Access Compliance Report

Public Rights-of-Way

(Curb Ramps)

Main Street: SILVER_FOX_RD Cross Street: DRUID_LN Location: NE

ADA ID: RPRK211206170945 Ramp Type: Type 1 - Perpendicular Diagonal Initial Pass/Fail: Fail Overall Compliance: No Severity Score: 2

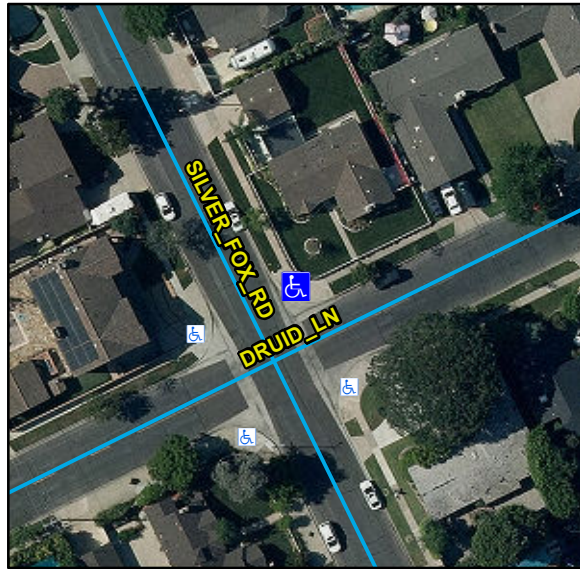
R204.3, R304.5.3, R302.7.2, STD 1115

Compliance	Description	Data	Compliance	Description	Data
N/A	Ramp Length (in)	134	N/A	Flare Type LT	
Yes	Ramp Width (in)	48			N/A
Yes	Ramp Run Slope (%)	3.6	N/A	Flare Slope LT (%)	N/A
No	Ramp Cross Slope (%)	2.8	N/A	Flare Traversable LT	N/A
N/A	Landing Present	N/A	N/A	Flare Type RT	
N/A	Landing Length (in)	N/A			N/A
N/A	Landing Width (in)	N/A	N/A	Flare Slope RT (%)	N/A
N/A	Landing Run Slope (%)	N/A	N/A	Flare Traversable RT	N/A
N/A	Landing Cross Slope (%)	N/A	N/A	DWS Provided	N/A
N/A	Landing Movement Obstructed?	N/A	N/A	DWS Contrast	N/A
	Landing Movement Type	N/A	N/A	DWS Length (in)	N/A
N/A	Landing Shared	N/A	N/A	DWS Full Width	N/A
N/A	Clear Space	Yes	N/A	DWS Offset Left (in)	N/A
N/A	Clear Space To Crosswalk (in)	N/A	N/A	DWS Offset Right (in)	N/A
N/A	Marked Crosswalk 1	No	N/A	Marked Crosswalk 2	No
	Crossing 1 Direction	W		Crossing 2 Direction	S
	Marked Crosswalk 1 Width (in)	N/A		Marked Crosswalk 2 Width (in)	N/A

N/A	Ramp Inside Crosswalk 1	N/A	Yes	Ramp Inside Crosswalk 2	N/A
	Crossing 1 Slope (%)	4.4		Crossing 2 Slope (%)	1.7
	Crossing 1 Cross Slope (%)	2.1		Crossing 2 Cross Slope (%)	2.4
N/A	Gutter Ponding	N/A	N/A	Curb Slope	3.8
No	Gutter Lip Height (in)	0.5		Road Run Slope (%)	2.4
N/A	Gutter Run Slope (%)	N/A		Road Cross Slope (%)	4.3
N/A	Gutter Cross Slope (%)	N/A			
Yes	Overall Surface Condition: Acceptable		No	Perp Joint Present	No
	Cross Gutter Present?	Yes		Spandrel Present?	Yes
	Replace Cross Gutter?	No		Replace Spandrel?	No

Remove & Replace Curb Ramp With Two New Directional Ramps or Equivalent. Grind Gutter Lip.
